ALLIANCE
FOR AUTOMOTIVE
INNOVATION

Auto Innovators Presentation on NHTSA Pedestrian Safety Global Technical Regulation

December 4, 2023

#1 - Defining the Test Area and Corresponding Test Zones

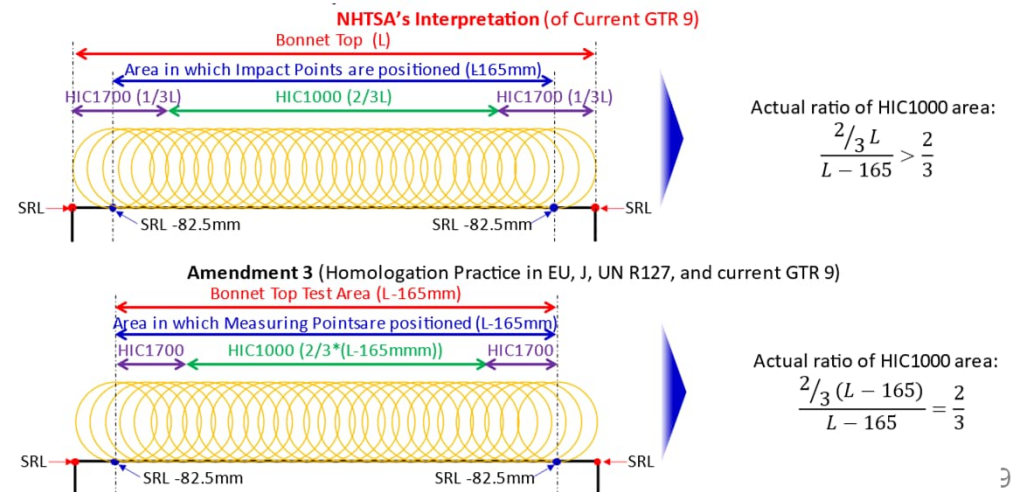
- Auto Innovators recommends not pursuing the “mark-up” approach discussed in the agency’s 2018 report.

- The areas for controlling head impact injury (1/3 and 2/3 of hood) are not equivalent.
- It could potentially result in undefined HIC 1000 and HIC 1700 zones, or circumstances where the ratio of HIC 1000 zones exceed 2/3 of the testable area.
- Similar issues would also likely arise if the agency were to adopt a hybrid approach that blends requirements from the GTR No. 9 and UN Regulation 127 test procedure.

#1 - Defining the Test Area and Corresponding Test Zones

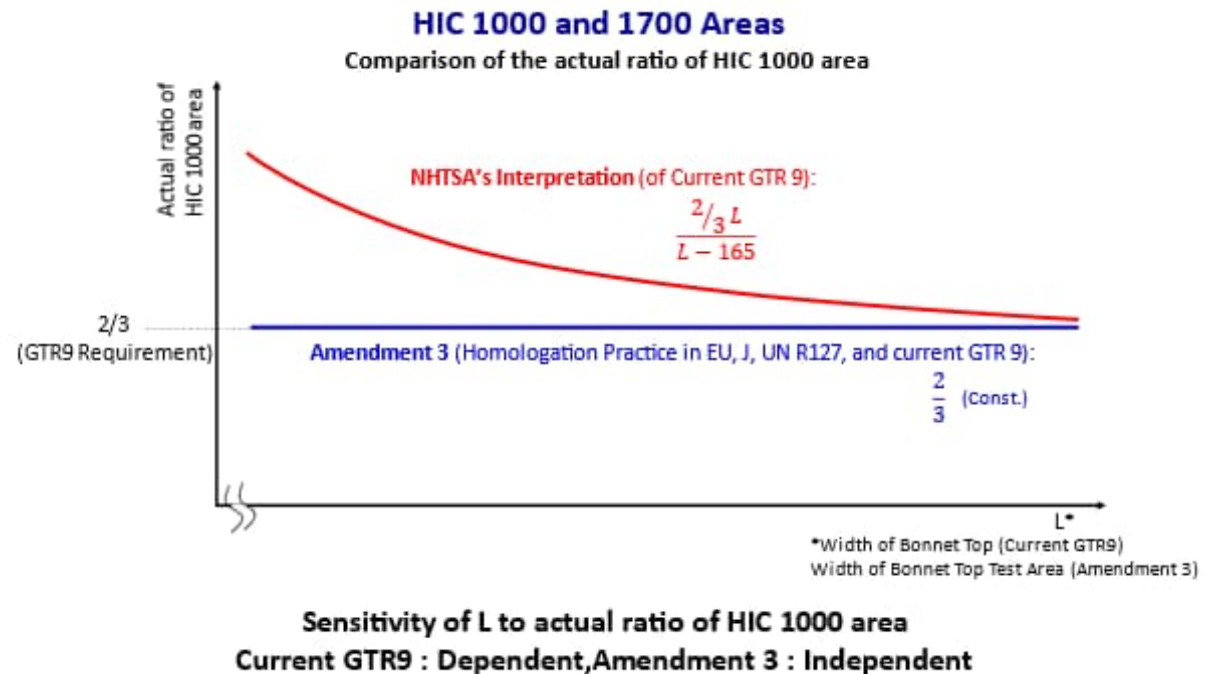
- For vehicles with smaller, narrower front ends, the actual ratio of the HIC 1000 area can become substantially larger than the fundamental 2/3 requirement in GTR 9 vehicle front end.
- This inappropriately drives more stringent requirements for smaller vehicles** and would have the counterintuitive effect of encouraging larger vehicles because of the comparatively lower ratio of HIC 1000 to 1700 zones in relation to the overall size of the vehicle front end.

#2 - Defining the Head Impact Point – Concerns with NHTSA Targeting Protocol

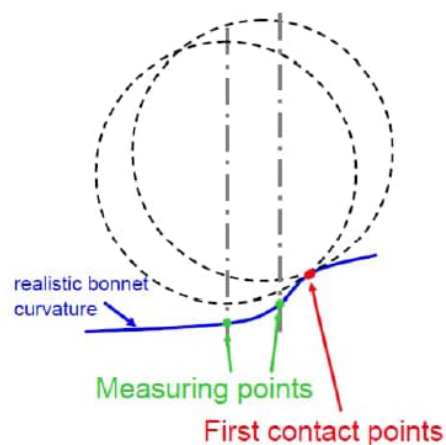
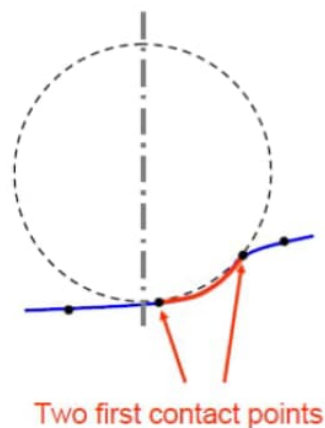
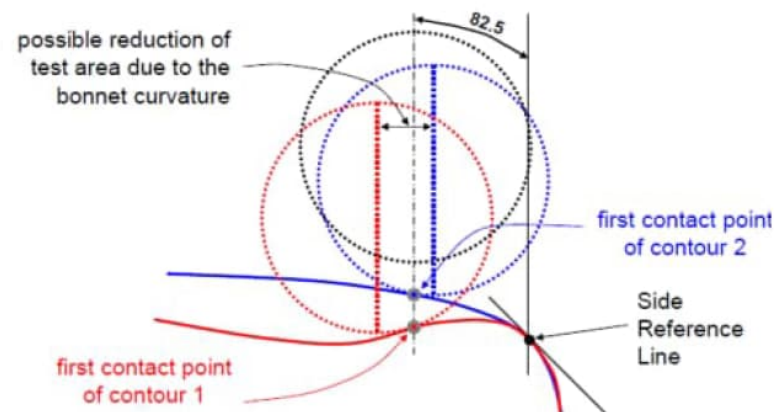
- The 3D POFC method introduces **repeatability and reproducibility concerns** whereby a “Point of First Contact” could be associated with multiple impactor positions.
- 3D POFC introduces **additional complexity in terms of test setup and execution**. For each test, it will be necessary to ensure the launch position/angle are clearly defined (relative to the vehicle) and additional steps may be needed to ensure the impact corresponds to a specific location on the vehicle hood.

Single Point of First Contact with Multiple Measuring Points

Single Measuring Point with Multiple Points of First Contact

Vehicles with different hood designs can be tested in the same way using the MP method versus 3D POFC

#2 - Defining the Head Impact Point – Concerns with NHTSA Targeting Protocol

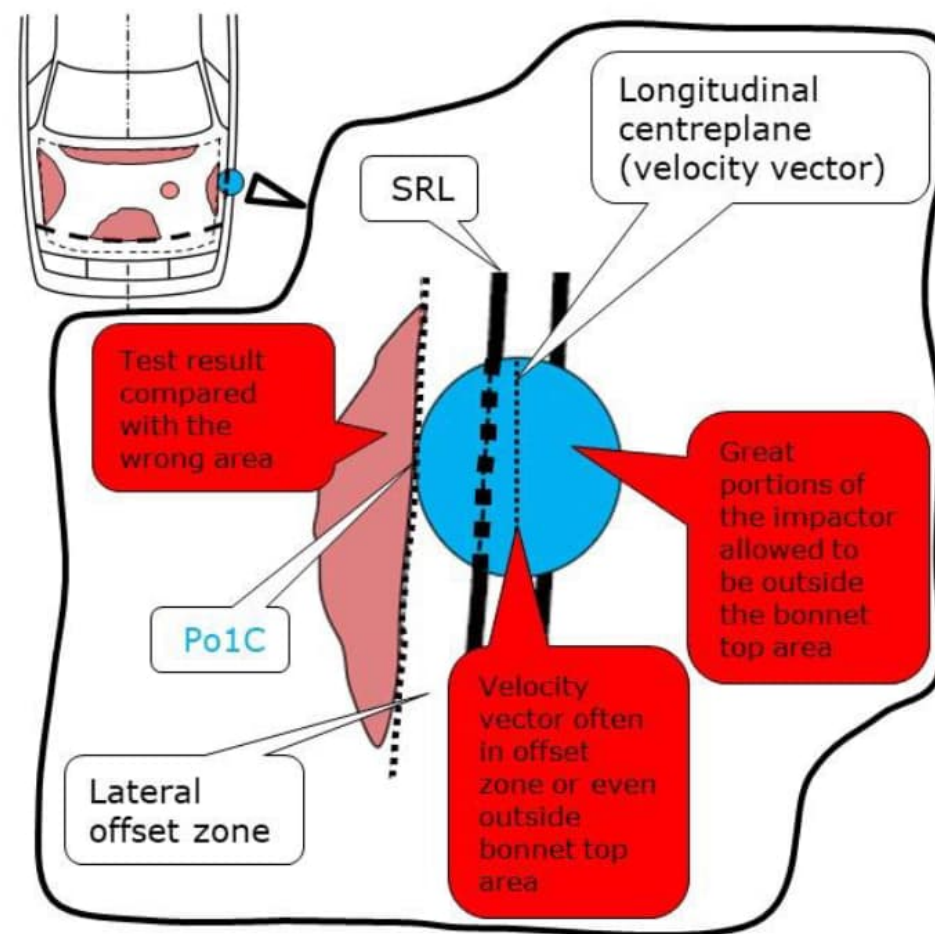
- **We are supportive of the 2D measuring point method** (proposed by OICA and in GTR No. 9 Amendment 3) to enhance the positioning of the head impactor for assessing pedestrian injury risk.
- **It provides a straightforward, objective, repeatable, and reproducible method for compliance testing and evaluation.** Conversely, the 3D Point of First Contact method (3D POFC and currently in GTR No. 9) does not achieve these goals and likely introduces additional and unnecessary complexity.
- **We therefore strongly urge the agency to adopt the 2D approach:**
 - Significantly more straightforward,
 - Limits unnecessary test burden,
 - Insures repeatability and reproducibility,
 - Better guarantees that impacts occur within defined testable areas
 - More closely aligned with the intent of GTR No. 9.
